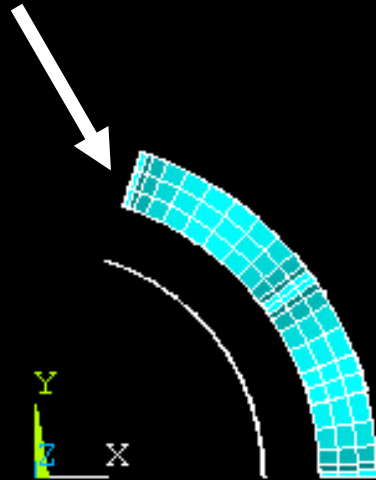
This part expands outwards in the radial direction and makes contact with the inner surface of the cylinder

What happens at bonded material interface? Should some sort of contact or interface elements be included?
